Safety Evaluation Report (Revised) for the Dewey-Burdock Project Fall River and Custer Counties, South Dakota

Materials License No. SUA-1600

Docket No. 40-9075
Powertech (USA) Inc.

U.S. Nuclear Regulatory Commission

Figure 1. Comparison of the Reported Drawdown and Drawdown from the modeling Software

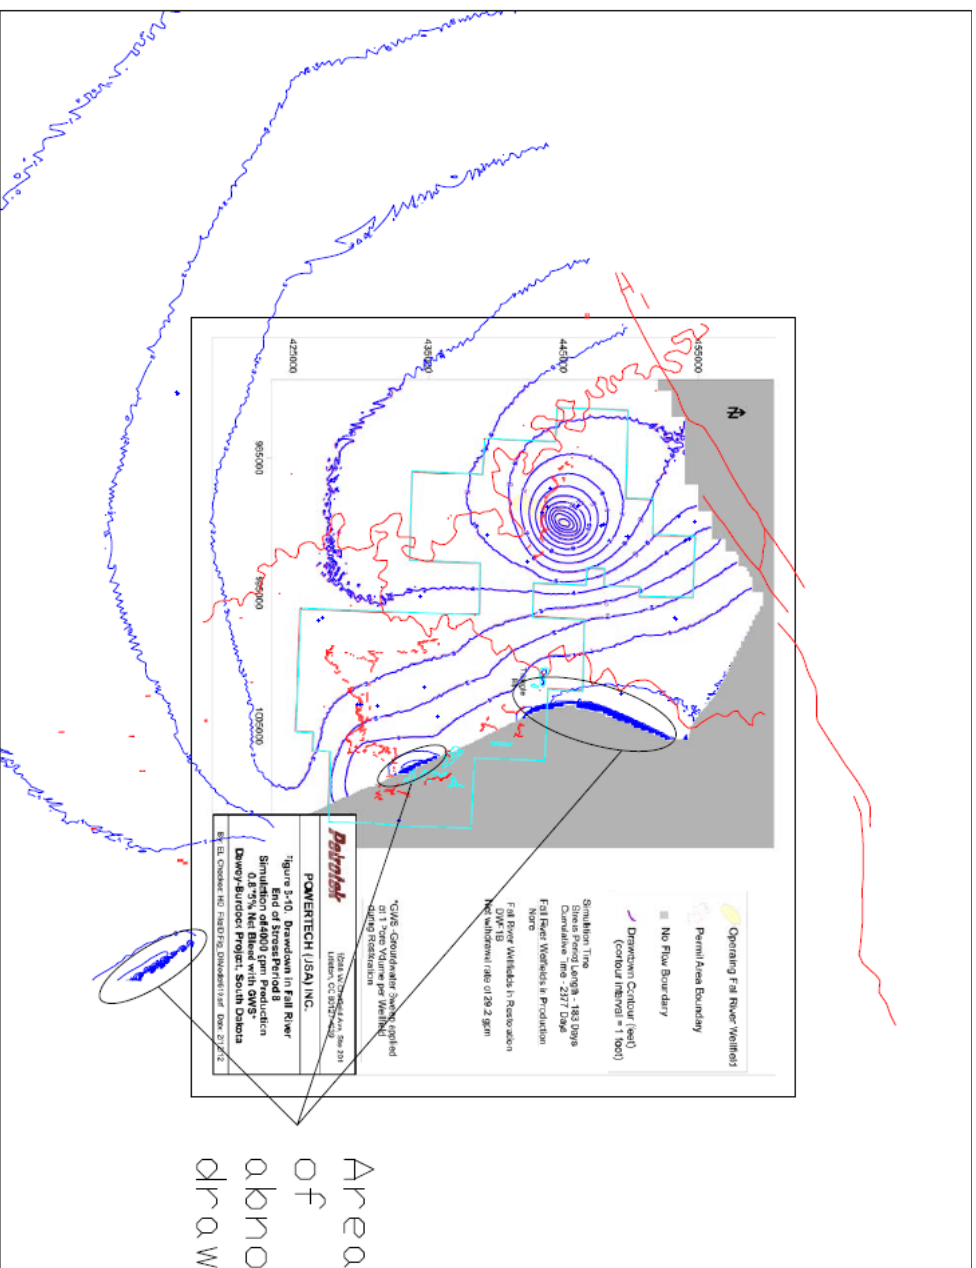
Staff reviewed the model geometry, hydraulic properties and parameters and locations of the boundaries. Several minor discrepancies were noted between the electronic files and the report (Table 1). In general, the discrepancies represent minor errors and are common for complex models. Most of the discrepancies would not appreciably impact the model predictions; however, staff was concerned about the abnormal drawdown adjacent to the GHB conditions (Figure 1). The abnormal drawdown may be attributed to discrepancies noted in the recharge, storativity or GHBs (see Table 1), or, conflicts with the starting head file.¹

Area
of
abnormal
drawdown

Staff corrected the model for discrepancies in recharge, storativity and GHBs, and established starting heads for the predictive simulation using the output from the steady-state calibration simulation. Correcting the model affected the predicted drawdowns in the Fall River Formation and Chilson Member, as shown in Figure 2 and Figure 3, respectively. The effect of the corrected model on the Fall River Formation model-predicted drawdown is to increase the drawdown by approximately 1 foot. The effect on the Chilson Member model-predicted drawdown is less than that for the Fall River Formation.
